ASSESSMENT REPORT

MIXED USE DEVELOPMENT, EASTLAKES SHOPPING CENTRE MP 09_0146 MOD 1

Figure 13: Approved Section at Gardeners Road (source: approved plans)

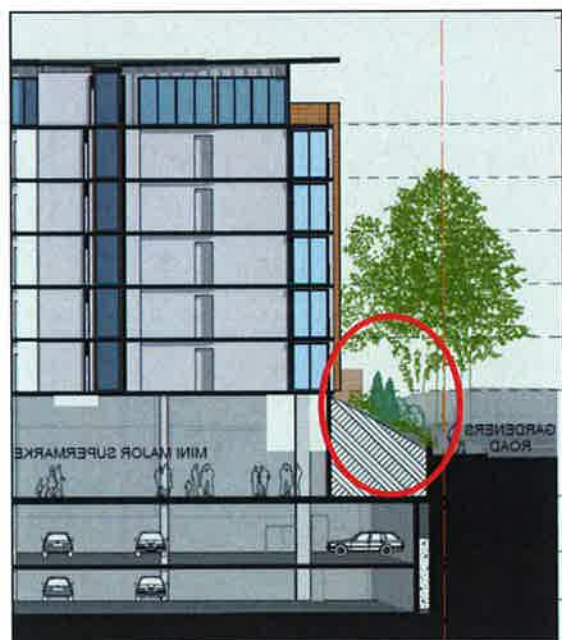
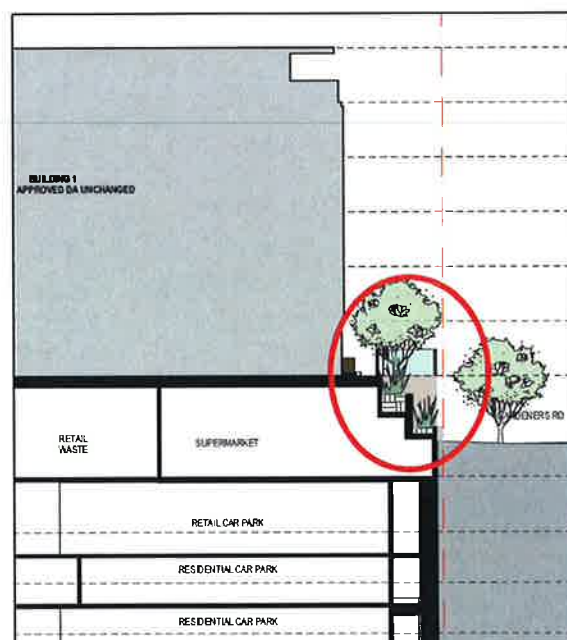
The modification seeks to extend the footprint of the podium towards the Gardeners Road boundary to provide additional retail floorspace. The Department initially raised concerns with this aspect of the modification, as it would result in a tall unbroken wall, up to six metres in height facing Gardeners Road (see **Figure 11**). Further, the revised design could not accommodate landscaping or trees within the front setback.

- the lower planter on the western side of the podium has a soil depth of only 400mm which can only support small ground covers. The Department considers the appearance of the podium could be significantly improved by lowering the base of the planter so it can support additional landscaping. A condition has therefore been recommended to this effect.
- at the western end of the podium, facing Gardeners Road, the podium wall extends above the emergency exit and service doors, resulting in a 5-metre-high structure at the edge of the footpath (see **Figure 15**). To reduce the visual impacts of the podium at this part of the site, the Department recommends the height be reduced to no greater than 3 m above the footpath and it be setback consistent with the remainder of the podium.

To address these concerns, the Proponent amended the design and incorporated a stepped podium along the Gardeners Road frontage. This has reduced the height of the podium wall at the footpath to a maximum height of 1.8 metres and allowed significant tree and shrub planting within the setback. Images of the proposed and approved development are shown in **Figures 13 to 15**. The Department considers the overall appearance of the proposal would now be similar to the approved development, albeit in a stepped, rather than a sloped form.

With a reduction in the podium massing at the western end, the provision of replacement street trees as well as landscaping within the front setback, the Department considers the proposed modification would retain a similar appearance to Gardeners Road as the approved development.

Figure 16: Approved layout of southern site showing the area on Evans Avenue that will be additionally overshadowed by the proposed building and the area overlooking the park that will have good solar access in the afternoons. (Base image source: approved plans)

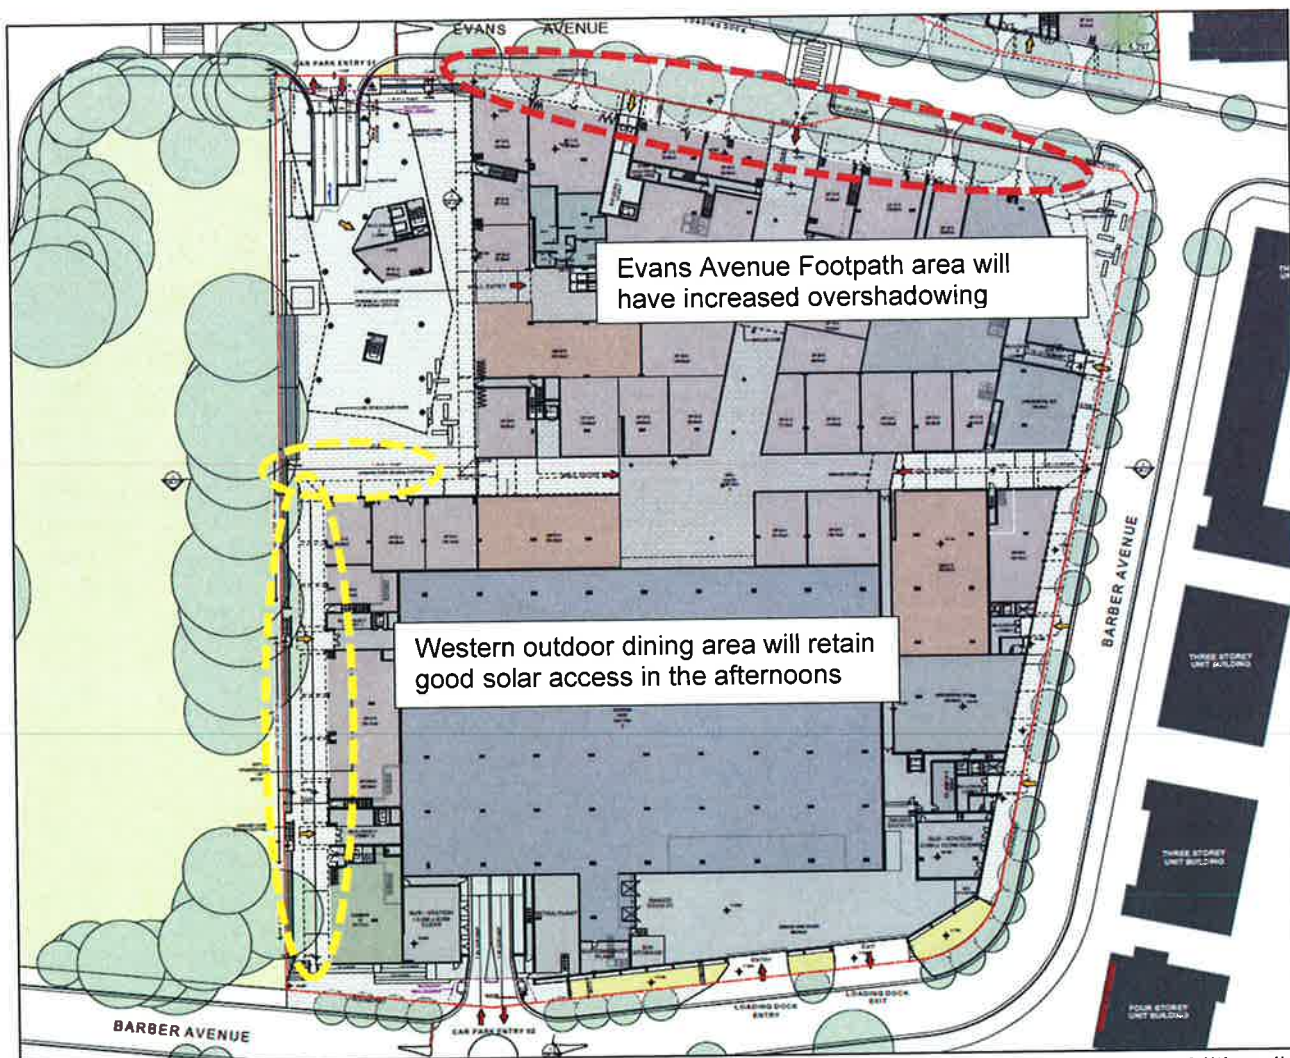
The increase in building height would result in additional overshadowing of the footpath throughout the day in mid-winter, although parts of the footpath would still receive sunlight at various times during the day.

In addition, the Department notes the footpath and any future outdoor dining areas would receive some access to sunlight at mid-winter and very good access to sunlight at other times of the year. Further, the approved development on the southern site incorporates retail units with the potential for outdoor dining overlooking the park to the west of the site, with excellent access to sunlight in the afternoon throughout the year (**Figure 16**).

Therefore, despite the additional overshadowing of Evans Avenue, the Department considers the modified development would still provide for active frontages along Evans Avenue with opportunities for outdoor dining.

Figure 17: Typical floor plan levels 2-6 showing setback control encroachment (base image source: Modification Request)

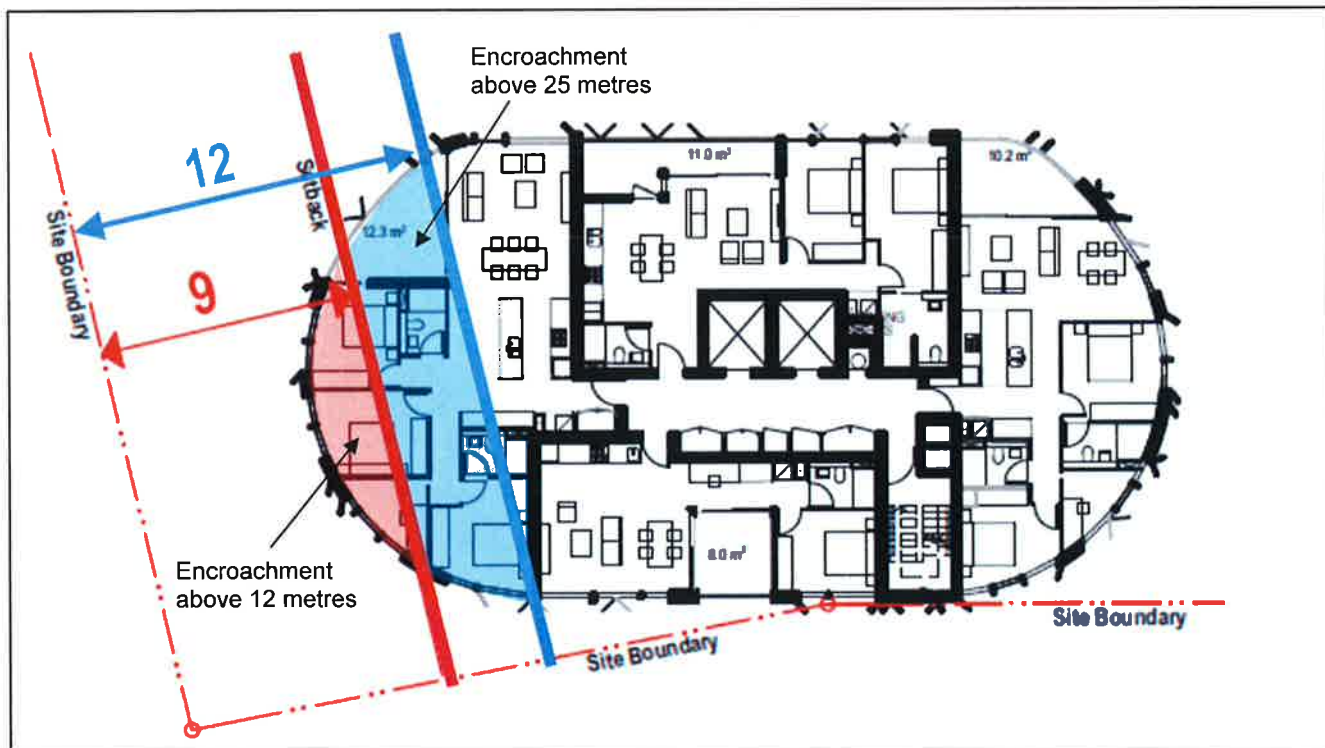
Building 1B would have a maximum height of 32 m to the top of the parapet and setback 6.47 m from the boundary with 16 Evans Avenue at its closest point. The proposal would therefore exceed the setback controls above 12 and 25 metres respectively. The extent of the non-compliance with the controls is shown in **Figures 17 to 19**.

The Department considers the proposed building separation is acceptable in this instance, given the proposed setback has been increased compared to the original approval (see **Figures 4 and 5**). Further, the Department considers the design of the building would minimise the potential visual impacts of the encroachment, as it would present as a slender curved shaped building, at the western boundary of the site.

To minimise potential privacy impacts on 16 Evans Avenue, the Department recommends additional privacy screening be provided to bedroom windows and balconies closest to the boundary and access to the edge of the roof terrace be restricted. The Department has recommended an amended condition requiring the above measures to be provided accordingly.

Figure 21: Proposed section through eastern boundary setback area (Source: Proponent's RTS)

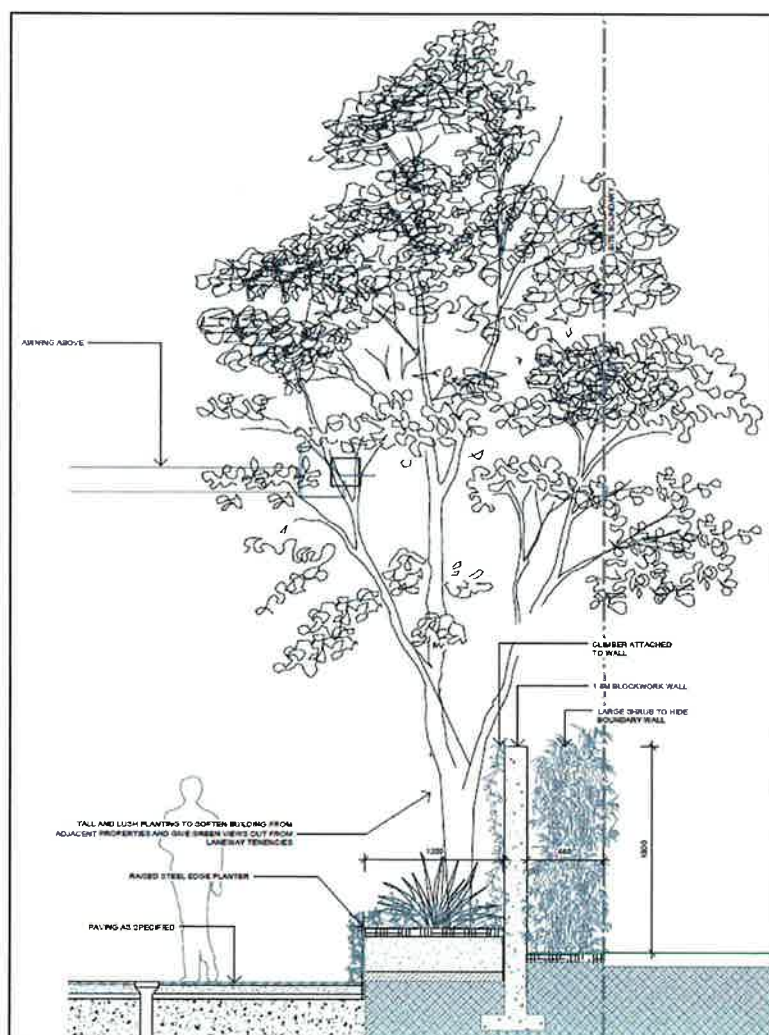
The proposal incorporates a 2 m wide landscape strip along the eastern boundary, including tree planting and shrubs to help screen the development when viewed from the adjoining site (**Figure 21**). A 1.8 m high blockwork wall is also proposed to mitigate acoustic and privacy impacts to the adjoining residential premises.

The Department considers the revised landscape treatment has the potential to provide a similar outcome to the approved development as it would appropriately screen the development. However, the proposal incorporates an awning above the setback area which may interfere with the proposed landscape planting. A condition is therefore recommended requiring the size of the awning to be reduced so that it does not extend into the tree canopy.

The Department also notes the Proponent's advice that the area will not be used for outdoor dining. To confirm this, the Department has recommended a condition specifying that no approval is granted for the use of this space for outdoor dining. The Department also notes existing conditions require the area to be lit at night and include CCTV to improve safety and reduce opportunities for concealment or entrapment.
